### **NEPA SCOPING AND AGENCY COORDINATION**

# Seward Airport Improvements Project (Project No. Z548570000)

Public and Agency Scoping Materials  
January 2017 through August 2018

Figure 15. 100-year flood map for Alternative 1.1.

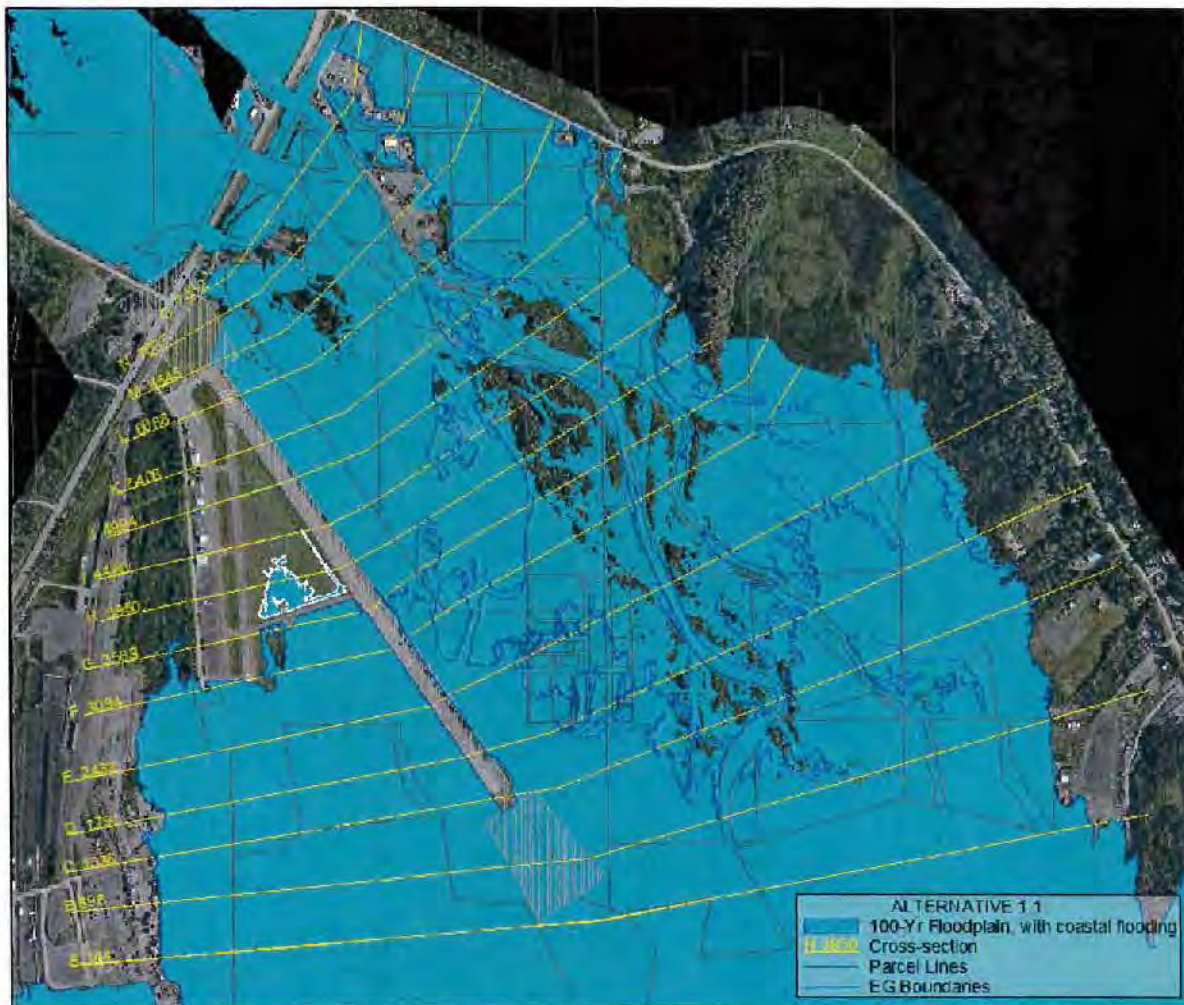
DOT&PF completed a flood study for the proposed project and is available for agency review. Alternative 1.1 would require placement of fill within the regulatory floodway as well as the floodplain (see Figure 2) from raising the runway. Increases to the base flood elevation (BFE) by as much as 4 feet would occur in some areas. This encroachment and subsequent rise in the base flood elevation would result in flood waters backing up onto private properties along the Resurrection River.

Figure 16. 100-year flood map for Alternative 2.2.

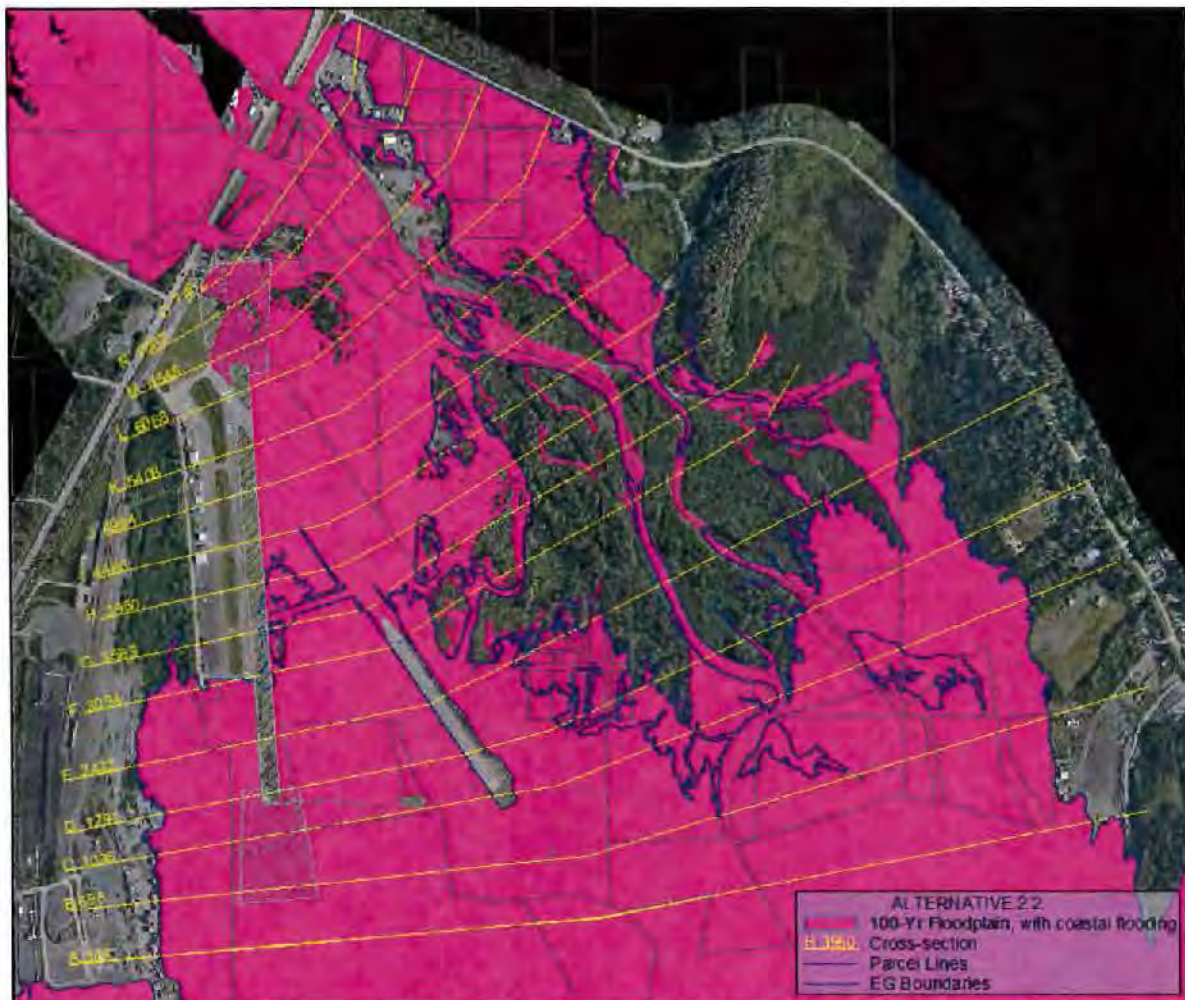
Fill for Alternative 2.2 would fall within the floodplain but outside the regulatory floodway (See figure 3). Alternative 2.2 would produce a BFE increase of less than 1 foot. As a result, the FIRM and Floodway will not need to be modified for this alternative.

Raising Runway 16/34 (Alternative 2.2) above the 100 year flood level (less than 1 foot) is not anticipated to raise the base flood elevation sufficiently to flood adjacent private properties more than the existing conditions (See Figure 6).
